Access Compliance Report

Public Rights-of-Way

(Curb Ramps)

Intersection ID: 10037289	Main Street: SARDIS_RD_NORTH	Cross Street: N/A	Location: SW
ADA ID: C43875A6DC67	Ramp Type: Perp	Initial Pass/Fail: Fail	Overall Compliance: No
Severity Score: 55			
Codes/Mitigation Info/Possible Solution		Field Measurements/Component Compliance

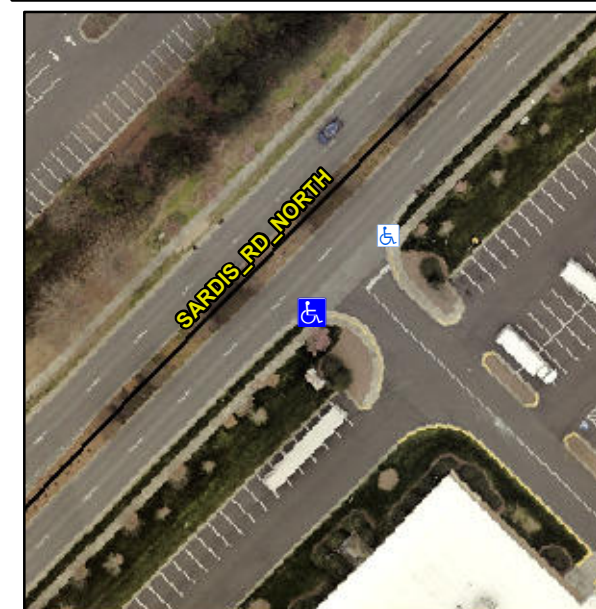
Not Found, R304.5.1, R304.2.2, R304.5.3

Compliance	Description	Data	Compliance	Description	Data
N/A	Ramp Length (in)	64.0	No	Ramp Slope (%)	9.8
No	Ramp Width (in)	33.0	No	Ramp XSlope (%)	7.4
N/A	Flare Type LT	N/A	N/A	Flare Type RT	N/A
N/A	Flare Slope LT (%)	N/A	N/A	Flare Slope RT (%)	N/A
N/A	Flare Traversable LT?	N/A	N/A	Flare Traversable RT?	N/A
N/A	Landing Length (in)	N/A	N/A	DWS Provided?	N/A
N/A	Landing Width (in)	N/A	N/A	DWS Contrast?	N/A
N/A	Landing Slope (%)	N/A	N/A	DWS Length (in)	N/A
N/A	Landing X Slope (%)	N/A	N/A	DWS Full Width?	N/A
N/A	Landing Curb? (Y/N)	N/A	N/A	DWS Offset (in)	N/A
N/A	Shared Landing?	N/A			
N/A	Gutter Ponding?	N/A	N/A	Gutter Slope (%)	N/A
N/A	Gutter Lip Ht (in)	N/A	N/A	Gutter X Slope (%)	N/A
N/A	Painted X Walk1?	No	N/A	Painted X Walk2?	N/A
	X Walk 1 Direction	To NE		X Walk 2 Direction	N/A
N/A	X Walk 1 Width (in)	N/A	N/A	X Walk 2 Width (in)	N/A
	X Walk 1 Slope (%)	5.1		X Walk 2 Slope (%)	N/A
	X Walk 1 X Slope (%)	0.5		X Walk 2 X Slope (%)	N/A

Remove & Replace Entire Ramp.
